VILLAGE DESIGN REVIEW COMMITTEE DESIGN STANDARDS REVIEW

SUBJECT PROPERTY: 6660 old 28th street

APPLICANT: Thomas Kuiper of Kuiper & Kraemer

VILLAGE DESIGN REVIEW COMMITTEE COMMENTS:

A4.1

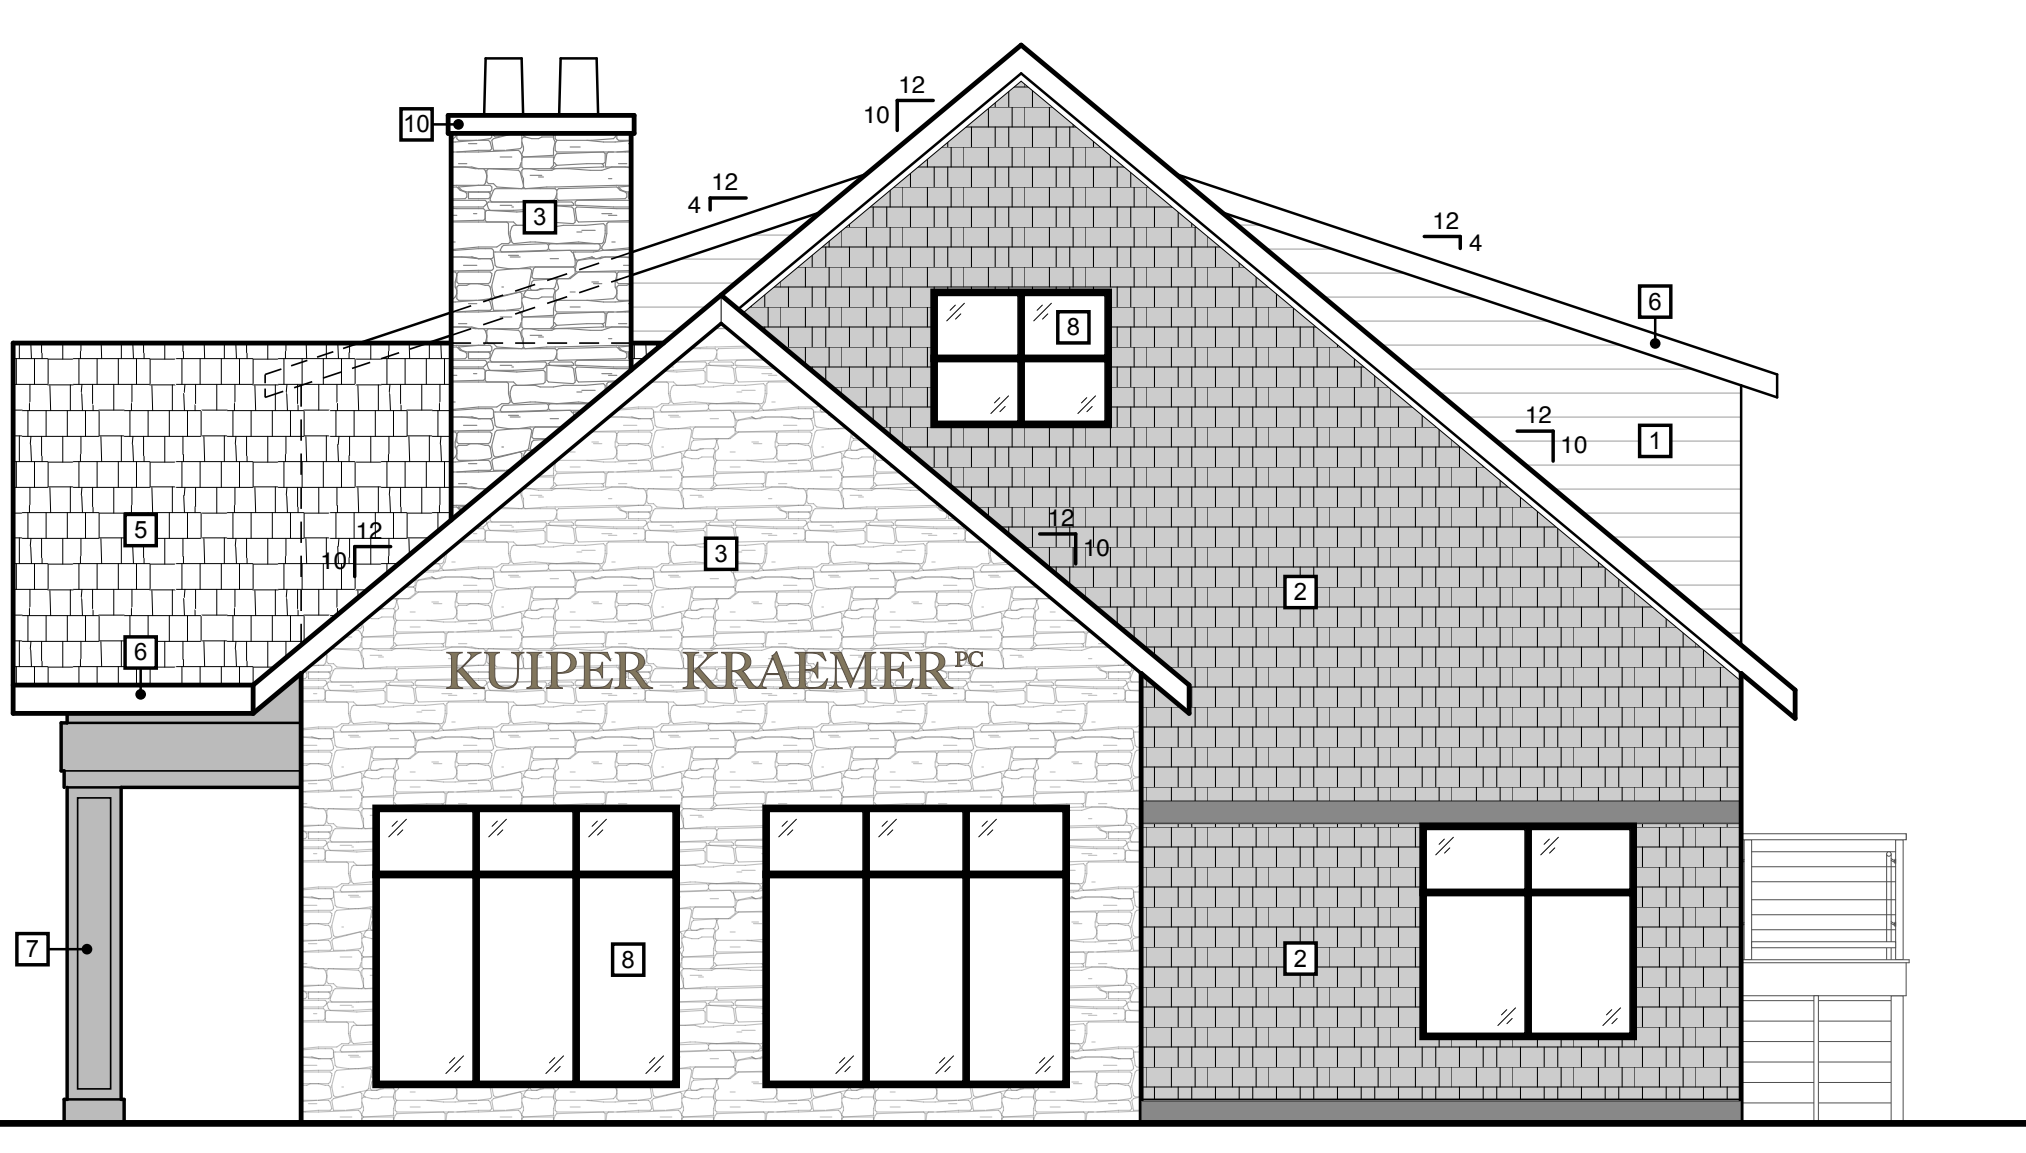
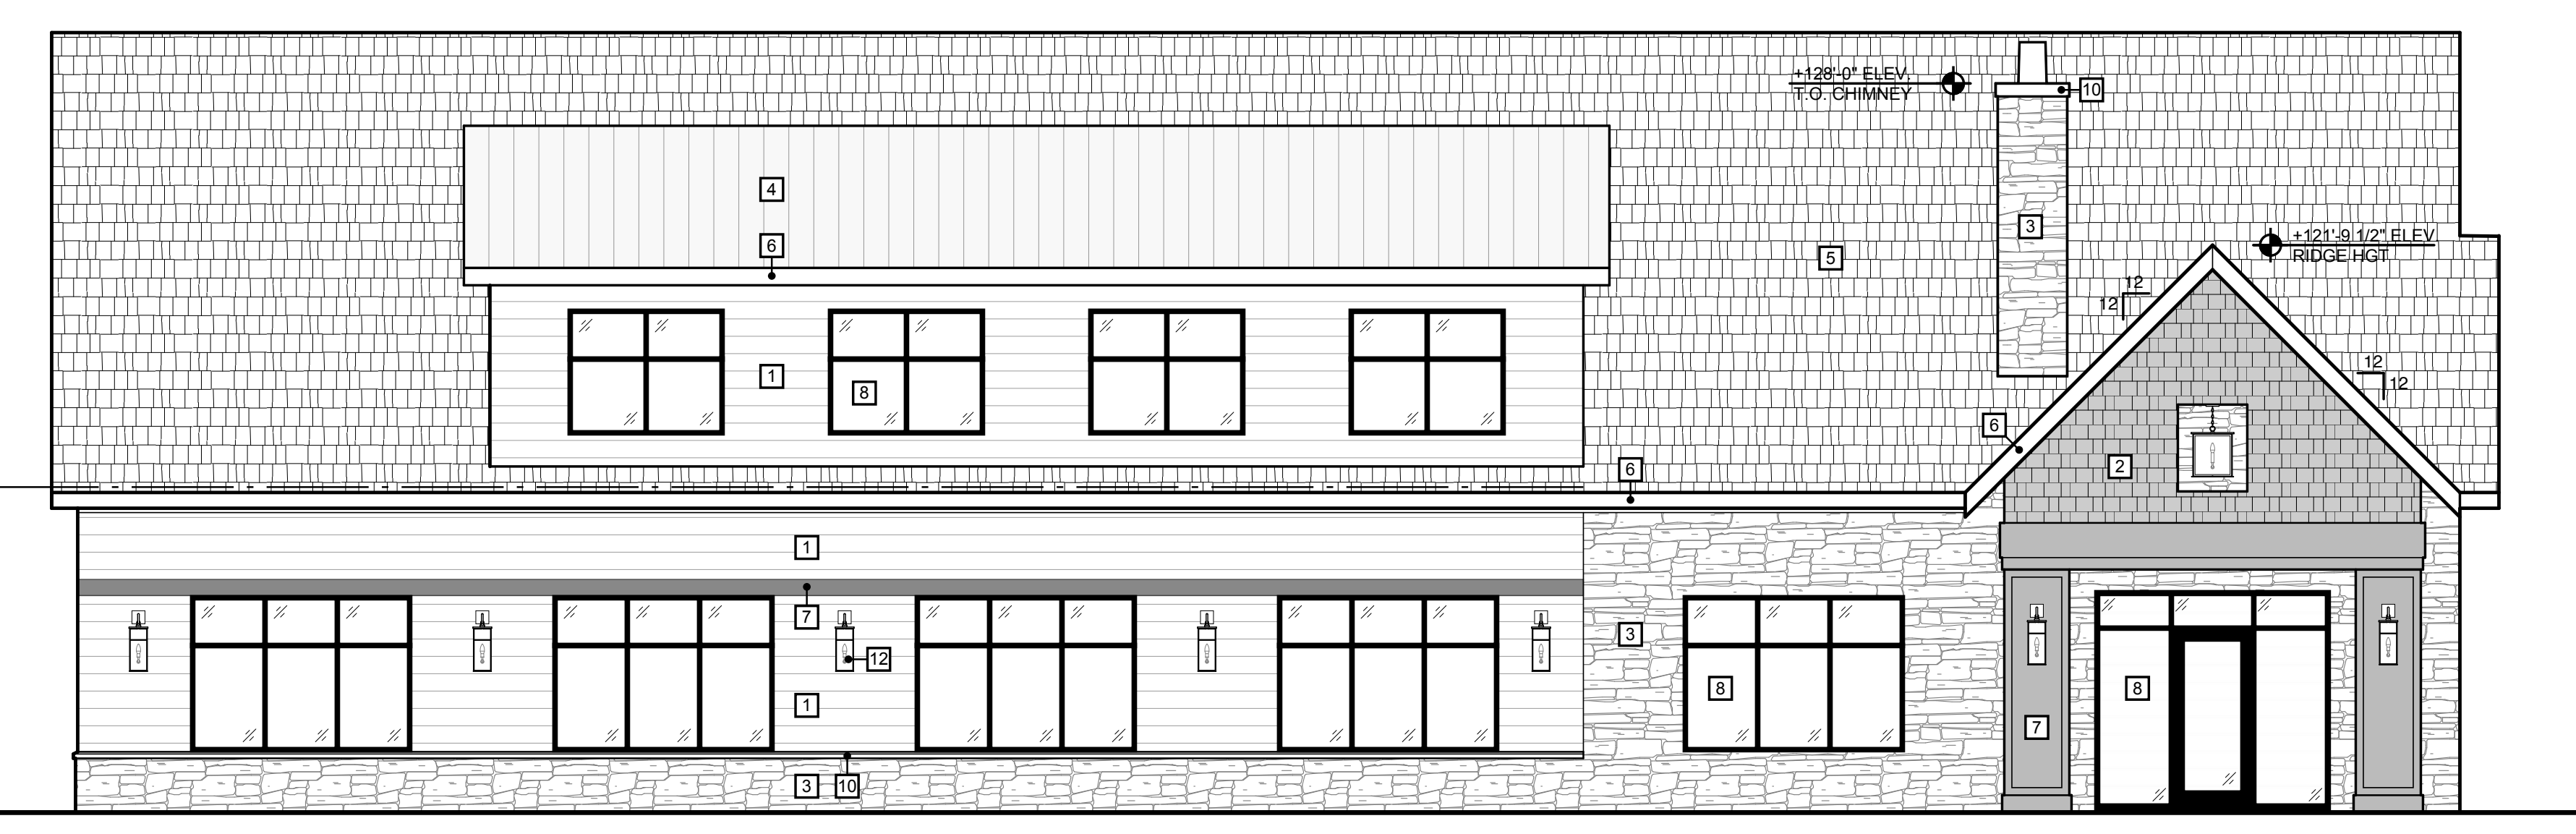
<p>4. At least 90% of the exterior finish material on all facades shall be limited to the following: glass; brick; stone; stucco; or wood.</p>	<p>Proposed in the Exterior Materials Legend on page A4.1 of the site plan are the following finishes:</p> <p>Front: Stone Veneer, Cement Board Lap Siding (amended in updated rendering), glass windows that measure roughly eight (8) feet by eight (8) feet, and accented with Cement Board Shake Siding.</p> <p>West: Cement Board Lap Siding and Stone Veneer, with five (5) large glass windows, six (6) feet by six (6) feet. The porch is Cement Board Shake Siding with Fiber Cement Trims.</p> <p>East: Six (6) large windows that measure roughly eight (8) feet by six (6) feet, and all Cement Board Lap Siding for the finish.</p> <p>Rear: Cement Board Lap Siding and Stone Veneer with four (4) doors (one at the mezzanine level) and two windows.</p> <p>All proposed exterior finish material indicated as Cement Board Lap siding does not appear to be consistent with this standards material requirements. The stone is in line with the standards.</p>

<p>5. No wall that faces a street or connecting walkway shall have a blank, uninterrupted length exceeding thirty 30 feet without including at least 2 of the following: change in plane, change in texture or masonry pattern, windows, or an equivalent element that subdivides the wall into human scale proportions.</p>	<p>The street-facing (north) façade meets the standard, with the maximum uninterrupted length being 14 feet. The same façade is interrupted by windows, and a change in texture and plane.</p> <p>The west façade, facing the connecting walkway, is interrupted by windows every 6-feet. The standard is met.</p>
<p>6. All sides of the building shall include materials and design characteristics consistent with those on the front. Use of inferior or lesser quality materials for side or rear facades shall be prohibited.</p>	<p>The use of Cement Board Lap Siding carries out on all sides of the building. The standard is met.</p>

<p>7. Each storefront must have transparent, non-reflective display windows on the street side, between one and eight feet from the ground.</p>	<p>On the street-facing (north) façade, there are three transparent windows. The two larger windows on the stone veneer are about one (1) foot from grade. The smaller window on the Cement Board Lap Siding is about two and half (2.5) feet from grade. Each side of the building has transparent windows.</p>
<p>8. For residential uses or residential above retail or office uses, 15% to 30% of surface area shall be vertically oriented transparent windows at upper floors measured from the line of the second (or third) floor to the cornice or fascia.</p>	<p>No residential use is proposed. This standard does not apply.</p>
<p>9. The primary colors of the building's exterior shall be compatible with the colors of the adjacent buildings and in character with those in the surrounding area.</p>	<p>The current proposed colors are greyish/tan. The applicant has indicated the paint colors will be pulled from the stone veneer tones, to appropriately complement the stone. The applicant has indicated he would work with the designer to settle final tones. The rendering shows a similar color palette that would be executed. The surrounding area has buildings in muted earth tones.</p>

<p>10. Facades that face the street or connecting pedestrian frontage shall be subdivided and proportioned using features such as windows, entrances, arcades, arbors, awnings, etc. along no less than 50 percent of the façade.</p>	<p>The street-façade (north) façade is divided into two planes and multiple windows.</p> <p>The entrance façade (east) has an arbored porch entrance, windows, and Wall Sconce Light Fixtures.</p>

- 1. 8.08.1 - The principal façade and front entry of the building shall face the street and when present, the non-motorized pathway network.**

The front entrance does not face the road. The applicant has provided maximum transparency, lighting that highlights the front façade, and brakes in the façade to provide

variety. The applicant is providing the required parking in the back with landscaped pathways to the side entrance. While the door is not located on the front façade, it is located on the corner near the front façade with an additional gable and pillars to further highlight the elements of the front façade. While the provided plan does not meet this standard, the VRDC found that the applicant provided sufficient evidence to support the entrance placement.

2. 8.08.8 - All sides of the building shall include materials and design characteristics consistent with those on the front. Use of inferior or lesser quality materials for side or rear facades shall be prohibited.

The applicant has provided high quality materials on all sides. However, the proposed design does not extend the stone veneer material provided on the base of the east and south side to the west side of the building. After review of the existing site conditions, it was determined that natural features on the side provide extensive screening to the west side of the building. Existing natural features include a wooded area on site that is to be preserved along with a steep gradient starting on the west side of the subject property and climbing westward onto the adjacent property. The VRDC found that the extension of the stone veneer base was unnecessary, and relaxation of these standards would have no detrimental impact on surrounding neighbors or the overall character of the district.
